DRAFT ENGINEERING EVALUATION

Facility ID 202754
Candlestick Point/Bayview Vehicle Triage Center
500 Hunters Point Expressway, San Francisco, CA 94124
Application No. 663096

Figure 1: Locations of Stack Outlets for S-1 and S-2

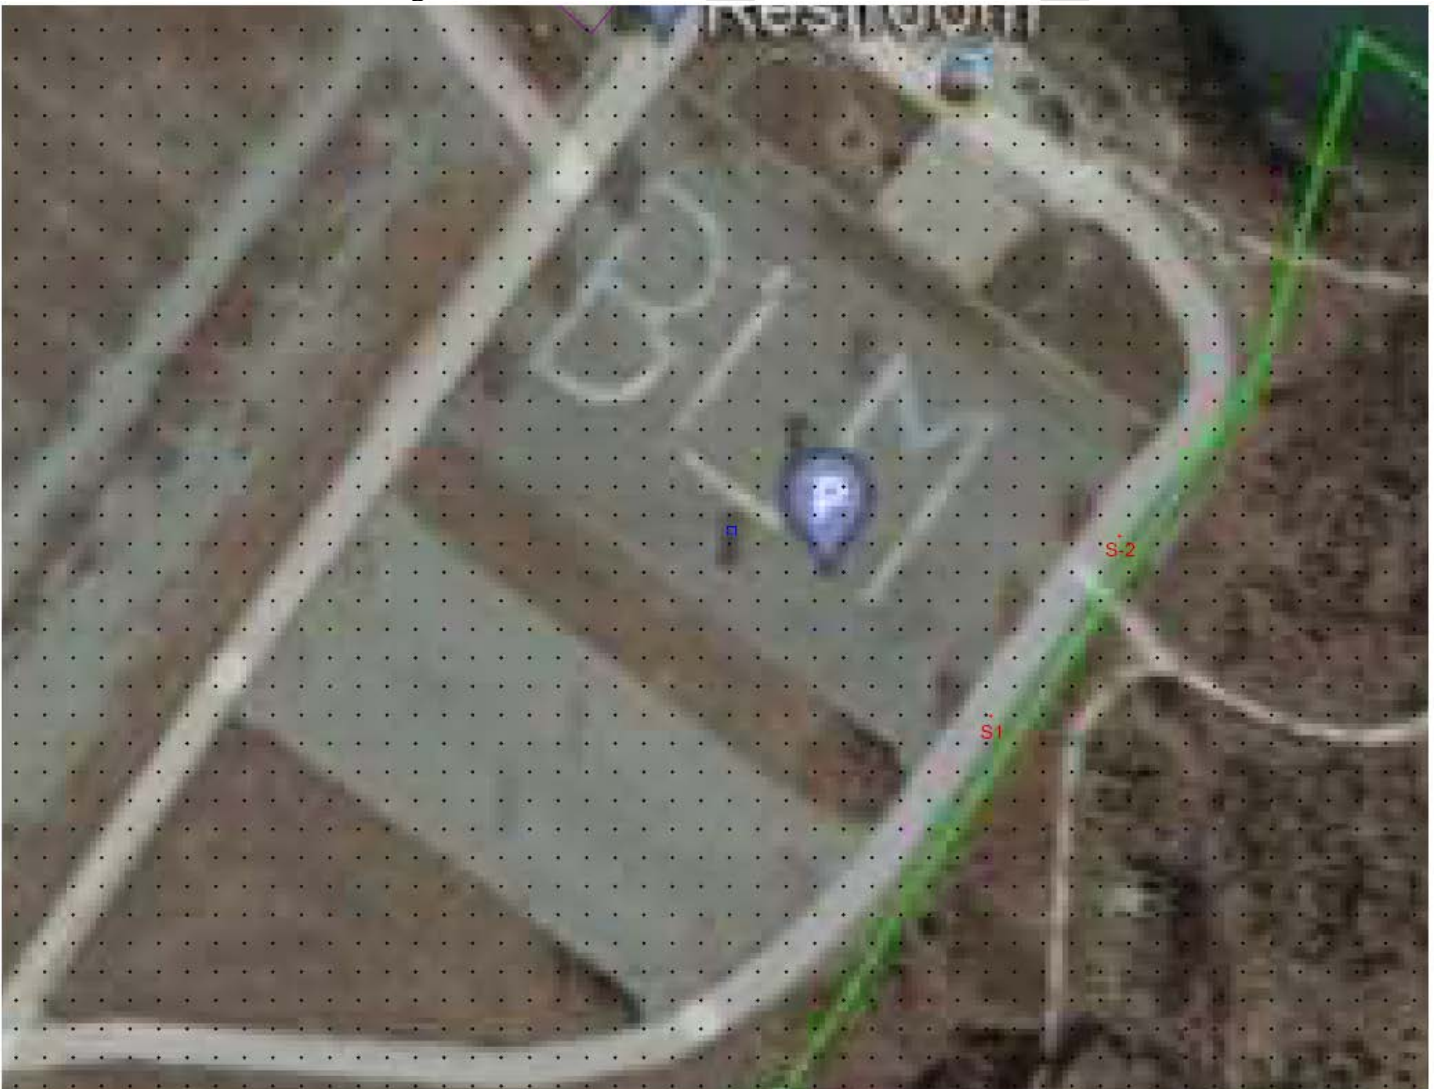
The results of the initial HRA found that cancer risk from the project would exceed 6.0 in a million. Air District staff then discussed other options with the applicant to find engine locations and stack outlet heights that would decrease the cancer risk to an acceptable level. The applicant also later accepted reduced annual hours limits for S-1 and S-2. The final HRA results are based upon 849 hours/year for S-1, 801 hours/year for S-2, relocating both diesel engines to the southern boundary of the East Lot, and raising each exhaust gas stack outlet (P-1 & P-2) to 15 feet above the ground. The final HRA results are summarized in Tables 7 & 8 below.

3. The owner/operator of S-1 and S-2 shall only operate these engines in the locations agreed upon during the application process (the southern boundary of the East Lot) unless written approval is obtained from the Air District to operate the engines in an alternate location. Additionally, the owner/operator of S-1 and S-2 shall not operate these engines unless the exhaust stack outlet is at least 15 feet above the ground for both engines.
[Basis: Regulation 2-5]
